MFN 08-307

Subject: **Response to Portion of NRC Request for Additional Information Letter No. 129 Related to ESBWR Design Certification Application - Auxiliary Systems - RAI Number 9.5-66**

**Response to Portion of NRC Request for
Additional Information Letter No. 129
Related to ESBWR Design Certification Application**

RAI Number 9.5-66

Figure 9.5-1. Fire Protection System Simplified Diagram

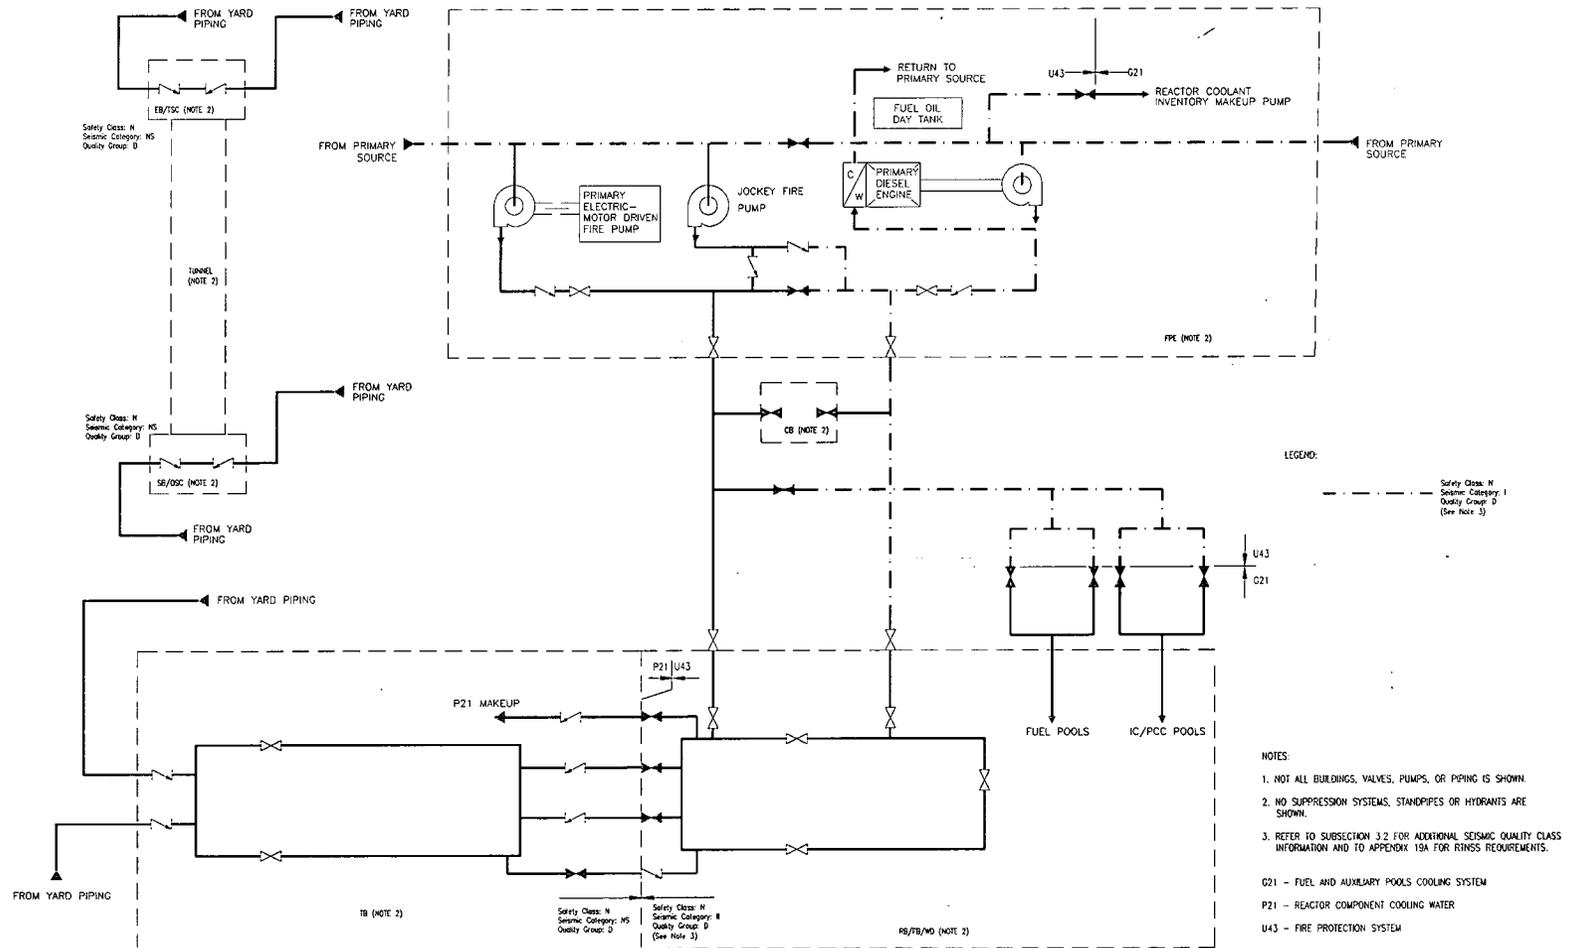
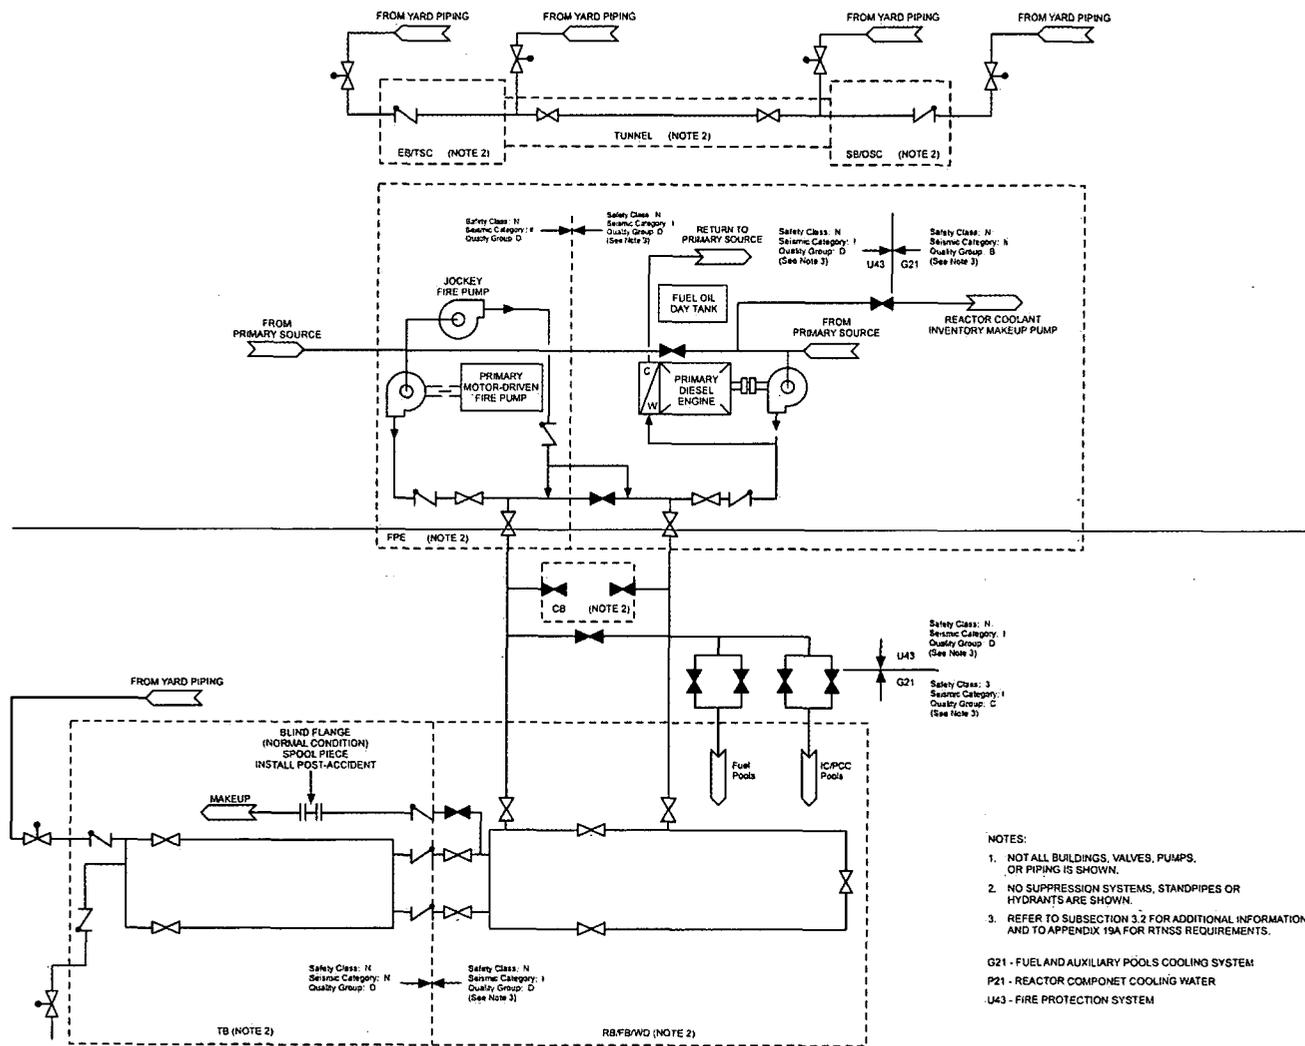
There are apparent errors and omissions on the FPS Simplified Diagram (DCD Tier 2, Revision 4, Figure 9.5-1) as follows:

a. Figure 9.5-1 does not show the SC I/SC II interface between the discharge line from the primary electric motor driven pump (indicated as SC II) to the reactor building header (indicated as SC I).

b. The makeup interface in the turbine building should be identified (what system is it going to) and it appears that the check valve in this line is shown incorrectly - the makeup flow arrow is pointing out of the reactor building header and the orientation of the check valve symbol in this line indicates that flow can only be into the header.

c. The class break between the turbine and reactor buildings refers to Seismic Category N according to Section 3.2.1, shouldn't this be NS?

d. In the event of an earthquake, the Seismic Category NS turbine building header could fail. The P&ID indicates that this would create two large (the header connections are assumed to be at least 6-inch diameter pipe) open flow paths from the Seismic Category I reactor building header to waste [sic. wait] until the manual isolation valves in the interconnecting piping could be closed. Has this been considered in the system design?

DCD Tier 2, Figure 9.5-1 of Revision 5 of DCD section is corrected to identify the SC I/SC II interface as requested. The only portion of FPS required to be Seismic Category I is the portion from the FPS storage tanks through the primary diesel FP pump which provides primary makeup to the Fuel Pool to satisfy RG 1.13, Revision 1, December 1975. There is a reliable backup from SC II primary electric FP pump. There is also a FAPCS SC I external piping connection which can be used to provide water to the Fuel Pools. For FPS system functions, RG 1.189 requires that equipment required for safe plant shutdown be analyzed for safe shutdown earthquake loading and should be provided with supports to ensure system pressure integrity. The piping and valves for the portion of hose standpipe system affected by this functional requirement should, as a minimum, satisfy ASME/ANSI B31.1. SC II piping satisfies the RG 1.189 requirements and the reactor building header is being changed to SC II.

DCD Tier 2, Figure 9.5-1 of Revision 5 of DCD section is corrected to clarify the P21 (Reactor Component Cooling Water) interface and to correct the check valve orientation.

DCD Tier 2, Figure 9.5-1 of Revision 5 of DCD section is corrected to show NS for the Seismic Category.

DCD Tier 2, Figure 9.5-1 of Revision 5 of DCD section is corrected to show the two manual valves are normally closed. This isolates the SC II Reactor building piping from the NS TB piping.
